**RES AMERICA DEVELOPMENTS INC., WHIRLWIND ENERGY LLC, AND  
HACKBERRY WIND LLC's APPEAL AND COMPLAINT OF  
ERCOT DECISION TO APPROVE PRR 830**

DOCKET NO. \_\_\_\_\_

Pursuant to P.U.C. PROC. R. 22.251, RES America Developments Inc. and its affiliates Whirlwind Energy LLC and Hackberry Wind LLC (collectively “RES”) file this complaint and appeal of the November 17, 2009 decision of the Board of Directors of the Electric Reliability Council of Texas (“ERCOT”) to approve Protocol Revision Request 830 (“PRR 830”). RES requests that PRR 830 be suspended while this appeal is pending and that, at the conclusion of this proceeding, the Commission reverse ERCOT’s decision and order that PRR 830 not be implemented. The grounds for RES’ appeal are set forth below.

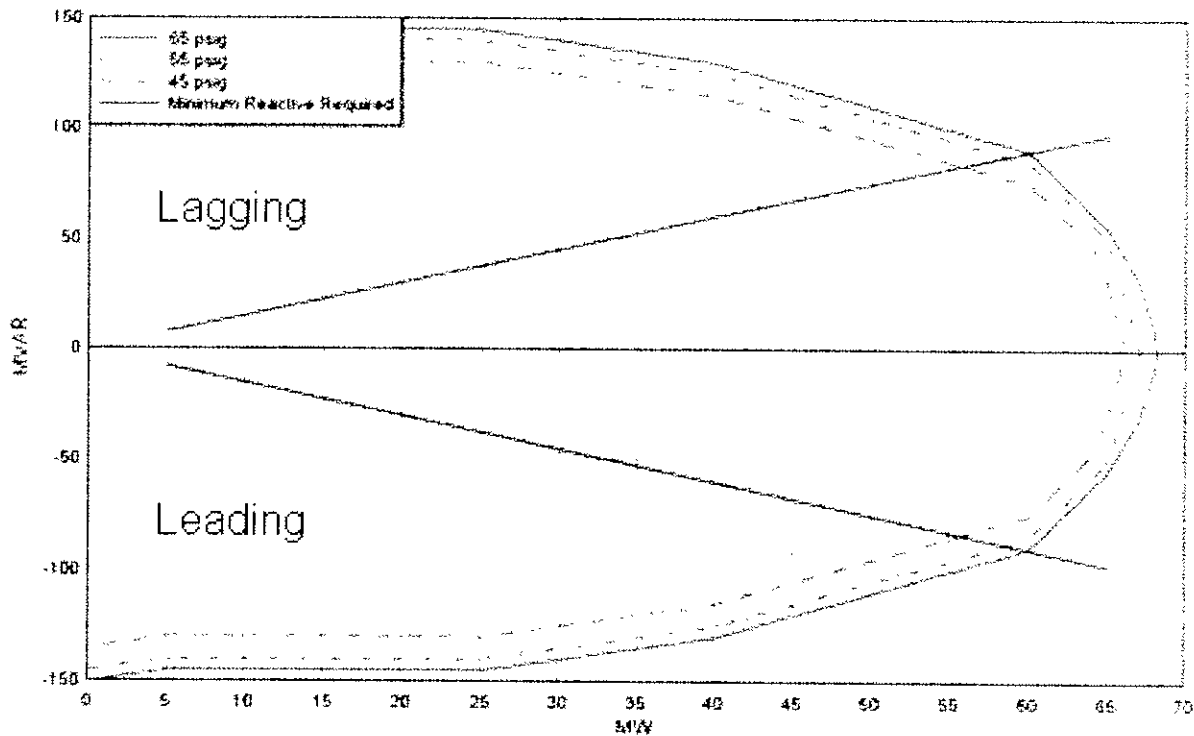
The current Protocols are clear that URL refers to Reactive Power produced when a Resource is operating at its rated capability, and that the required reactive capability varies with the Resource's real power production. At full output, a Resource must be capable of providing reactive power per its URL. There is no confusion there. The Protocols also say: "In no event shall the Reactive Power available be less than the required installed reactive capability multiplied by the *ratio* of the lower active power output to the generating unit's continuous rated active power output..." (emphasis added). There should be no confusion that the Protocols intend for Reactive Power capability to vary with output.

This clear meaning is supported by ERCOT's actions and in Other Binding Documents. WGRs have clearly and repeatedly communicated their Reactive Power capability through the interconnection process, the asset registration process, the synchronization approval process, ERCOT surveys, and in response to request letters from ERCOT.

ERCOT's Resource Asset Registration Guide, effective March 10, 2009, reflects the Protocol requirement that the "Minimum Reactive Required" vary with a Resource's output. The chart reproduced below appears in version 4.03 of the Resource Asset Registration Guide, published two months after ERCOT issued its Reactive Power interpretation. WGRs registering their assets clearly indicated that their Reactive Power capability varies with power production.

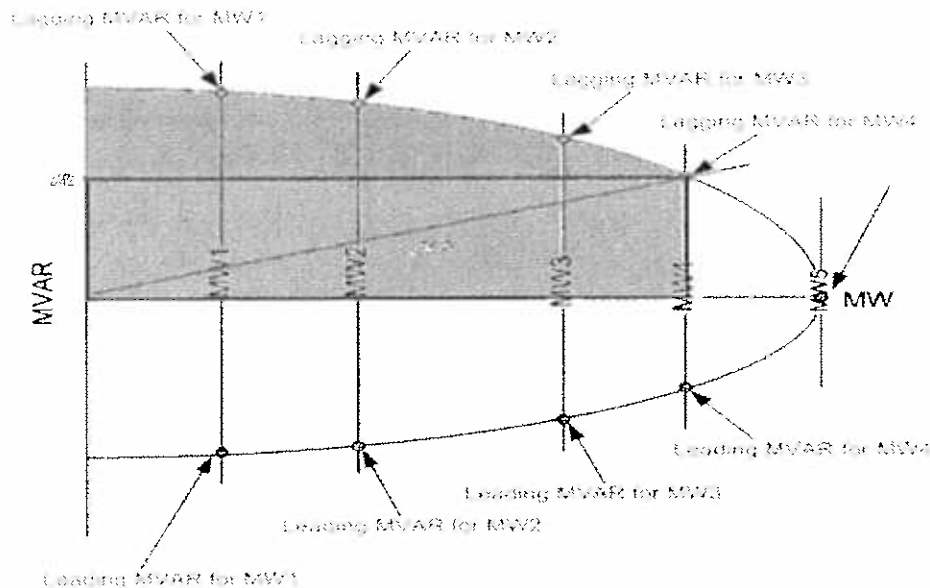
Note in the diagram below the green range of reactive capability above the URL line that the ISO can dispatch if conditions warrant. We chose MW4 as the Net Demonstrated Capability to use in determining the resource's URL, since MW5 would yield a URL of 0 MVars and operation at the knee of the curve is never advisable under normal conditions for machine stability reasons. Please also note that the language sets as a goal the equalizing of reactive Dispatch of units connected to a common bus in an effort to ensure that all units are providing their fair share of the obligation to supply voltage support, an unpaid/community service.

The statement, "If the PRR instead required all generators to simply make available whatever level of reactive power capability is inherently provided by their units...." is an interesting one to be sure. Although reactive production, from a fuel standpoint, is relatively inexpensive, the long term wear and tear and initial capital costs are the components typically cited in Federal Energy Regulatory Commission (FERC) approved reactive tariffs in other jurisdictions where reactive is a paid service. NextEra's proposed solution would have them placing a free call option on other resource owners' capital and long term exciter and generator maintenance costs as a way of shifting wind's reactive obligation to the rest of the system. Even though this approach is entirely unacceptable, it is noteworthy that in it NextEra effectively admits that reactive obligations are not being met and searches for another party to carry that responsibility.

**Figure 1. +/- .95 Power Factor Criteria**

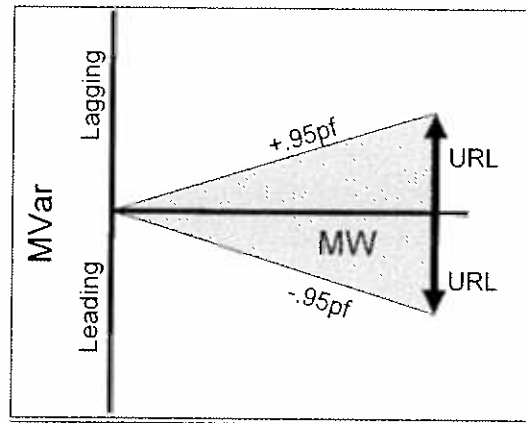
- (1) WGRs are required to provide VSS and must be capable of operating at a power factor of +/- .95 or less over the full (MW) net power output range of the Resource, supplied to the ERCOT Transmission Grid, and measured at the POI to the TDSP in order to maintain a Voltage Profile established by ERCOT. This requirement is graphically depicted in Figure 1. The quantity of Reactive Power measured at the full rated capability of the Resource is the URL.

**Figure 2. Fixed URL Criteria (based on +/- .95 Power Factor)**

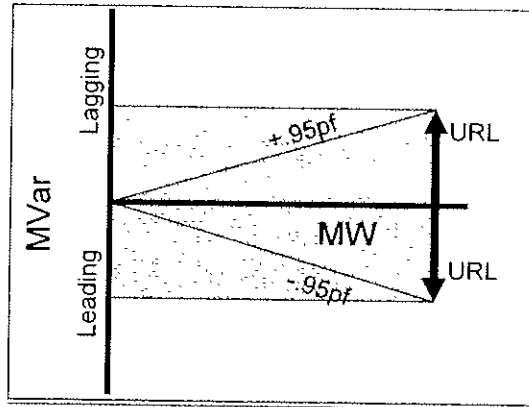
- (2) WGRs may be required to provide VSS beyond what is required in paragraph (1) above only if the TSP or ERCOT shows, through a System Impact Study, that such capability is required to ensure grid safety or reliability. The amount of additional reactive capability required to be provided by the Resource shall not exceed the URL specified in paragraph (1) above and be available at all MW output levels over the full output range of the Resource. This requirement is graphically depicted in Figure 2. This additional reactive capability may be provided through any combination of automatically switchable static reactive devices (i.e. switched shunts) and/or dynamic reactive devices (i.e. SVC, Statcom, etc.) so long as the requirement to ensure safety and reliability is met.

**PRR830 will result in redundant and excessive reactive capability where it is not needed**

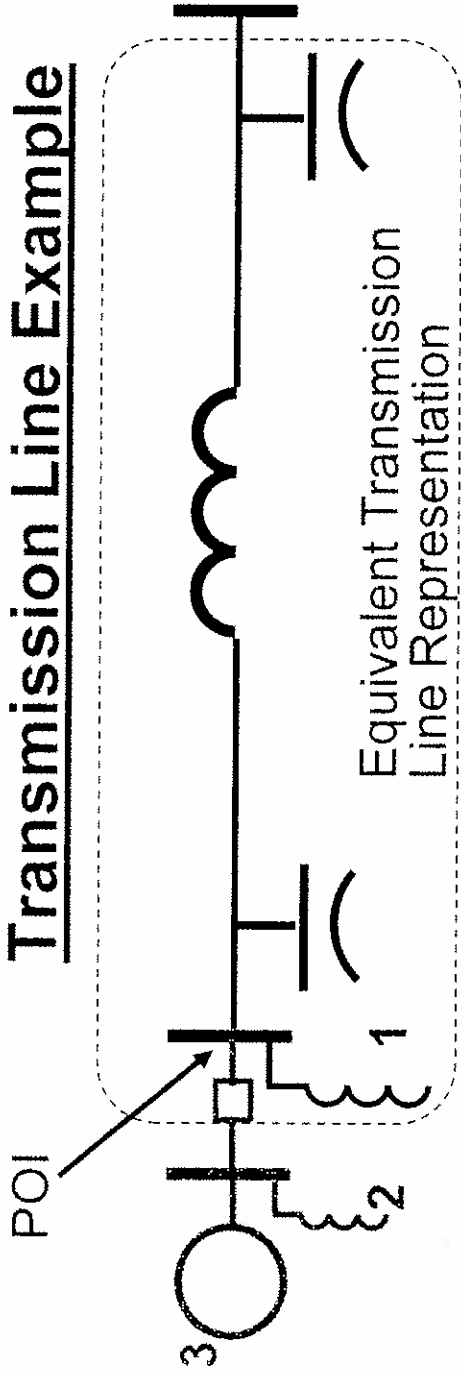
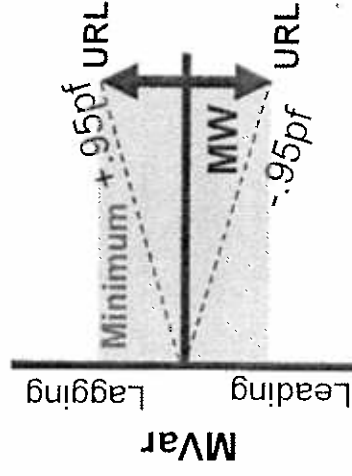
1. Transmission Owner must provide shunt reactors to offset line charging when wind is calm and generator is not generating
2. PRR830 would have the Generator install an additional shunt reactor to meet its URL requirement for leading reactive capability over its range of output
3. Inherent Generator reactive capability

### Transmission Line Example

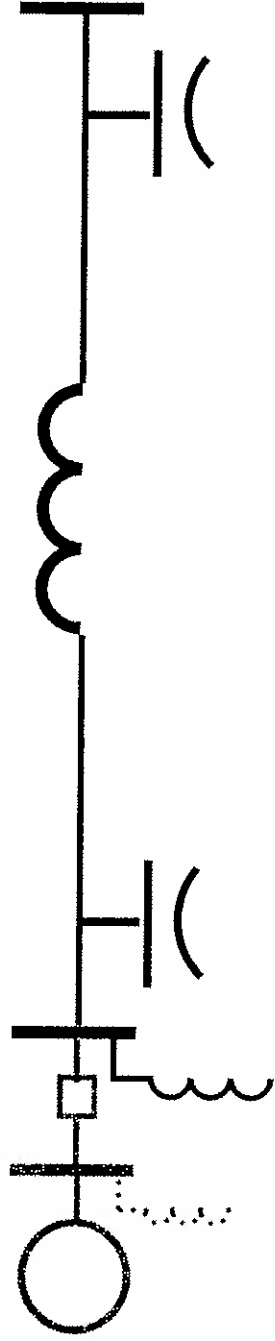
**PRR830 will result in the wasteful installation of redundant reactive resources.**

Generator shunt reactor (or capacitor) would not be required to meet its URL requirement for leading (or lagging) reactive capability over its range of output unless shown to be required by the System Impact Study

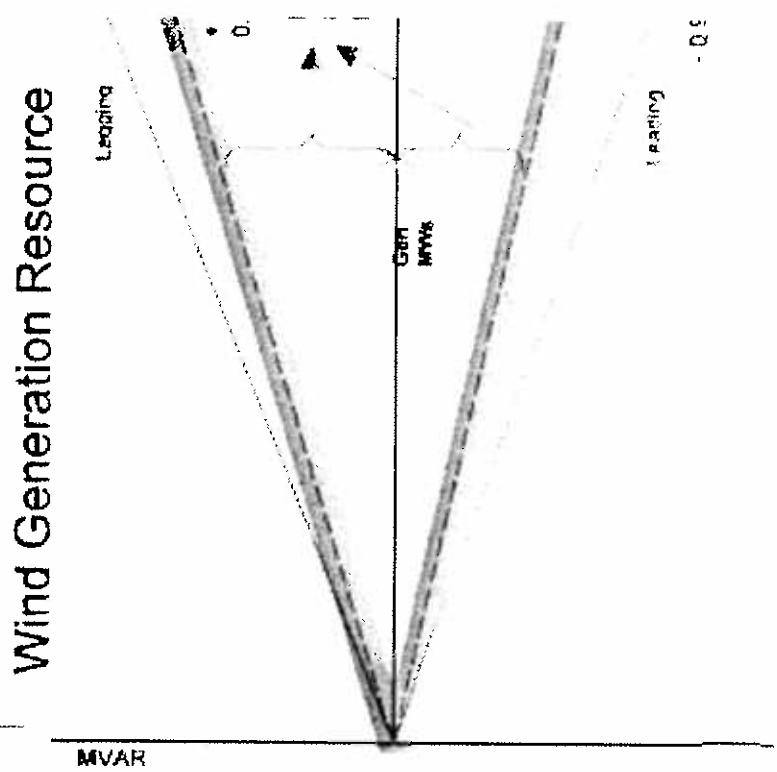
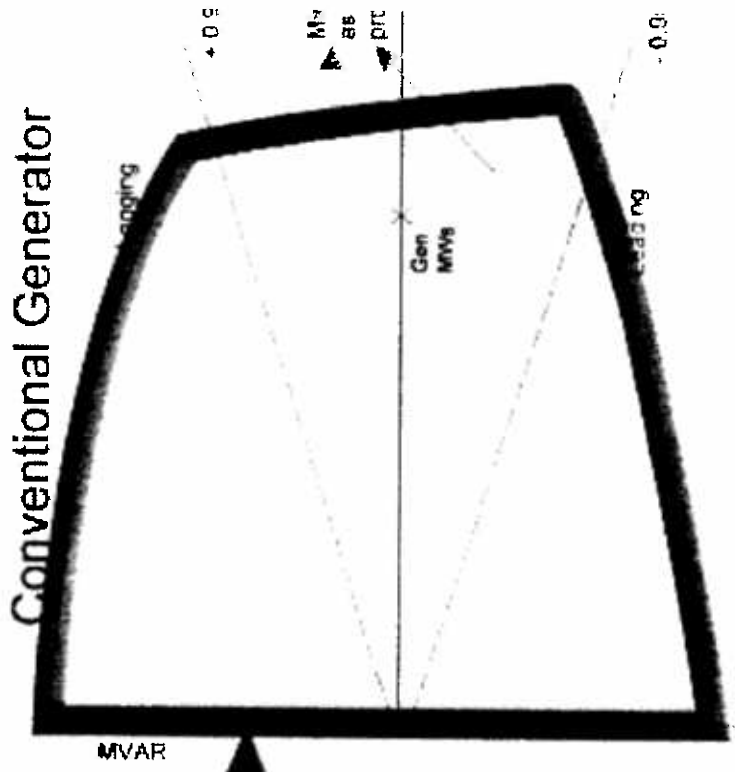
shown to the right are the reactive capability curves for a conventional generator and a WGR

As seen from the figures, each generator is required to provide a + 0.95 to -0.95 pf range support
